Service Campaign 496

M15x/M161 – Potential coolant leak from radiator delivery pipe

ATTENTION: This document replaces MAS003074 MSC 22-12, please discard any paper copy of the previous bulletin

DATE: SEPT 21 2022

***Examples of NOT OK**

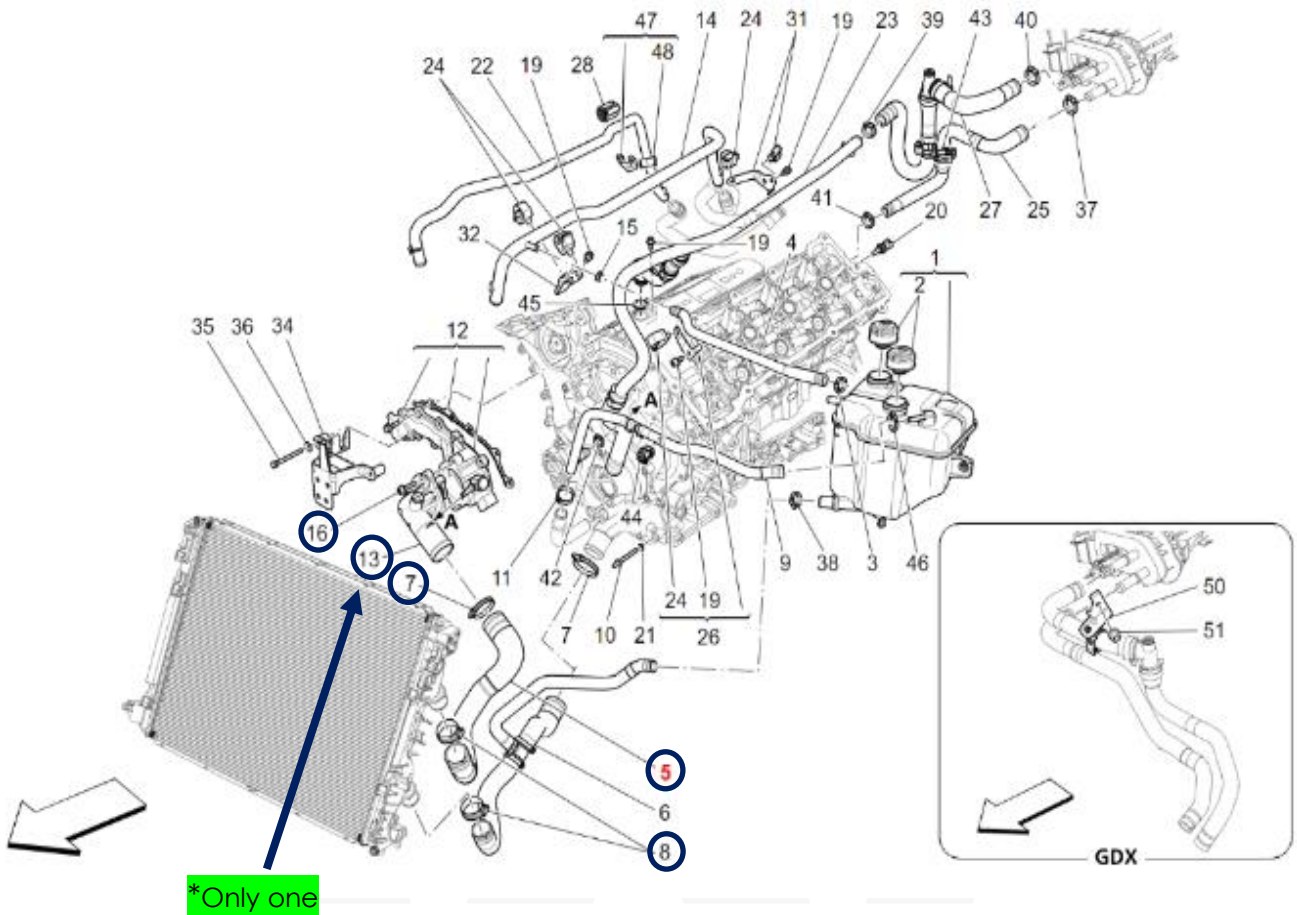
5. With the engine idling, open the front hood and check for drops or leaks of coolant between the Thermal Pressure Switch Cover and the Radiator Delivery Pipe. Located in the area indicated by the images below.

6. **OK** ▶ No coolant contamination or leak is found; the inspection is finished. No other actions are required.
7. **NOT OK** ▶ Coolant contamination is found and leaking. Take multiple CLEAR pictures at different angles of the leak. **Open BOL for "SUPPORT REQUEST" attach pictures, vehicle scan, and await further instructions.**
